A REVIEW OF THE OCONEE-3 PROBABILISTIC RISK ASSESSMENT:
INTERNAL EVENTS, CORE DAMAGE FREQUENCY

N. A. HANAN, D. ILBERG, D. XUE, R. G. FITZPATRICK, T. L. CHU

DEPARTMENT OF NUCLEAR ENERGY
BROOKHAVEN NATIONAL LABORATORY
UPTON, NEW YORK 11973

AUGUST 1985

Figure 3.3 Supporting Logic for Transient Event Tree Top Event B, Failure of RCS Heat Removal

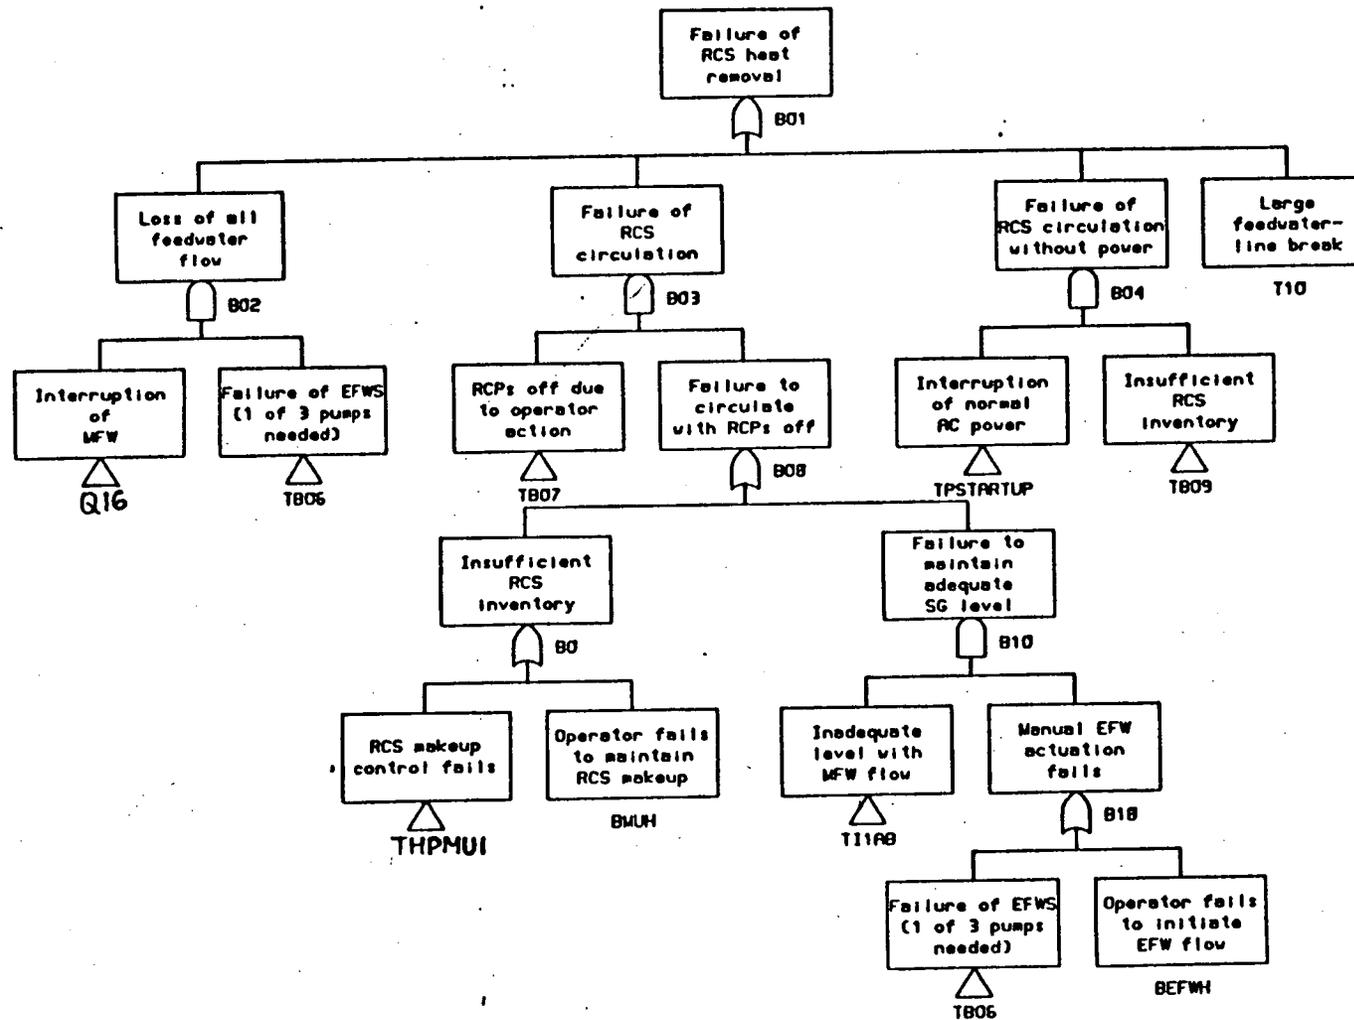
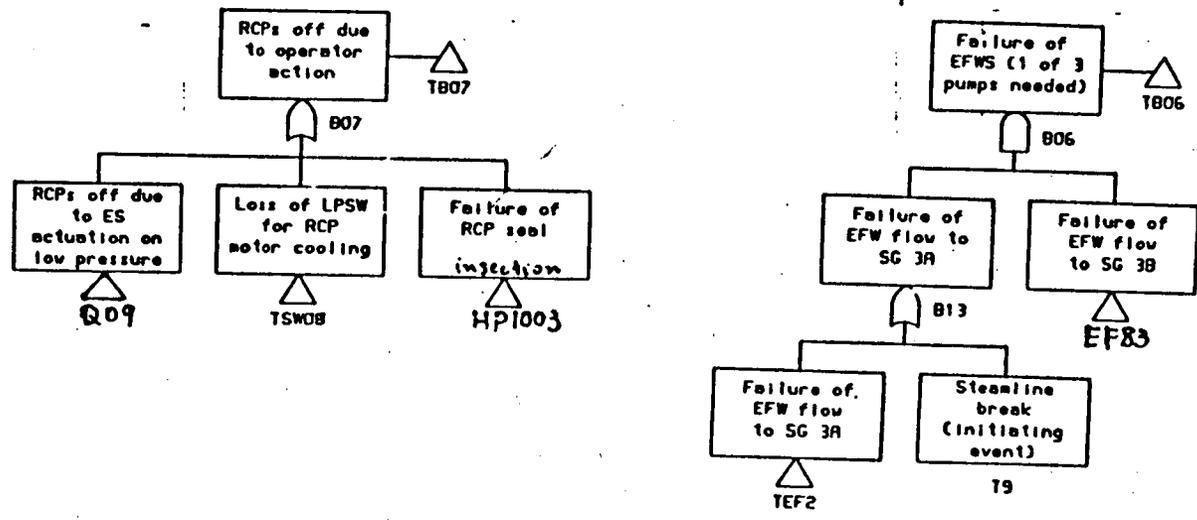
Function B, failure to maintain heat removal from the core and RCS via the steam generators is the next function. The development of the supporting logic for this function is given in Figure 3.3. The failure of the RCS heat removal would happen if:

The success of function B indicates the achievement of hot shutdown, and the failure of function B indicates a demand for forced cooling by the HPI system to avoid core damage (feed and bleed). This mode of cooling requires the opening of the PORV or one SRV, event P, to provide a path for decay-heat removal cooling and the success of the HPI system, event U_T . The failure of event P (Fig. 3.4) is conservatively considered to lead to a core damage; this is very conservative but its contribution to core damage is negligible and this assumption is used for both the OPRA and the BNL review. Failure of the HPI system in the feed and bleed mode of operation is represented by U_T (Fig. 3.5) and includes the operator's failure to actuate the system, a procedural step in the Oconee Emergency Procedures.⁴

Figure 3.9 Event Tree for Small-Break LOCA Events

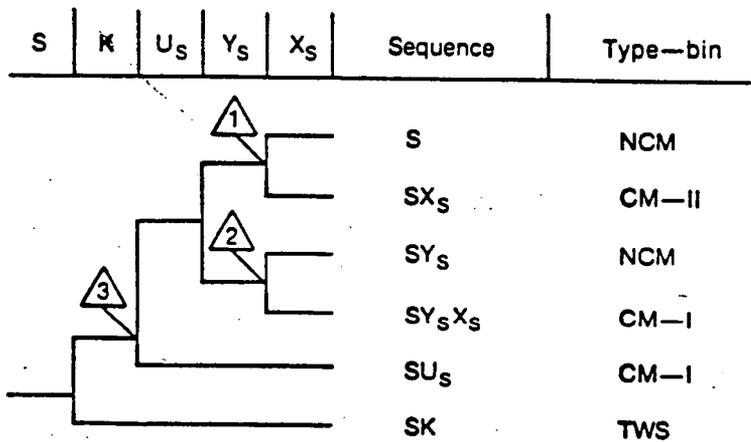
The first question in the small-LOCA event tree, Figure 3.9, refers to the subcriticality function (K). If this function fails, a small-LOCA ATWS occurs; this sequence was not further characterized in the ATWS event-trees because of its very small contribution to core damage compared to the other ATWS.

If HPIS is successful (\bar{U}_S) the function "failure to maintain RCS makeup supply" (Y_S) is analyzed. If this function fails, either because the RBCS fails or because the operator fails to terminate the RBSS, the inventory in the BWST will be depleted in about 2 hrs. and the operators must start the high pressure recirculation (function X_S with the occurrence of event Y_S ; gate XS02 in Figure 3.10). Failure of this function (X_S) results in core damage. Note that, for the very small LOCAs in this review, the RBSS is not automatically initiated unless the RBCS also fails.

Figure 3.11 Event Tree for Large-Break LOCA Events

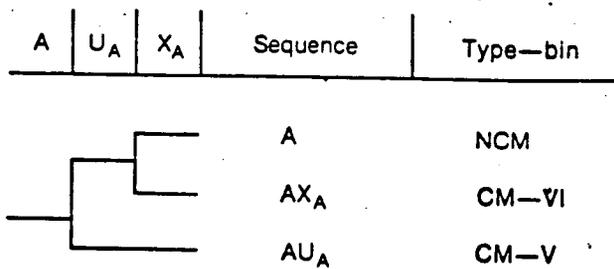
In the large-LOCA event-tree, Fig. 3.11, the first question is the availability of injection (U_A), and its failure leads to core-damage. With

Figure 3.12 Event Tree for SGTR Initiating Events

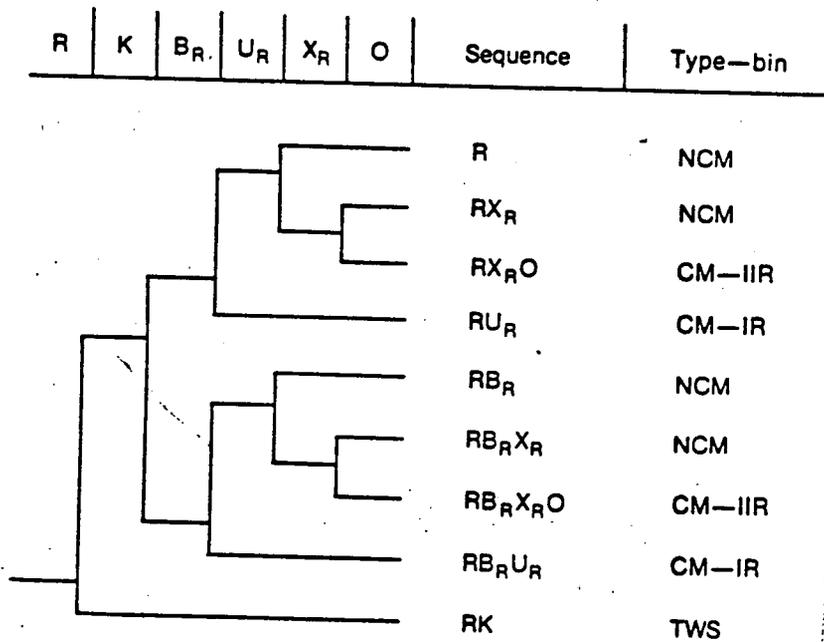
The SGTR is treated in OPRA as a special case of a very small LOCA; Figure 3.12 shows the SGTR event tree. If all feedwater pumps are lost, the pressure in the RCS may not decrease to the ES actuation setpoint and, therefore, manual HPI actuation is assumed to be required in both the OPRA and the BNL review.
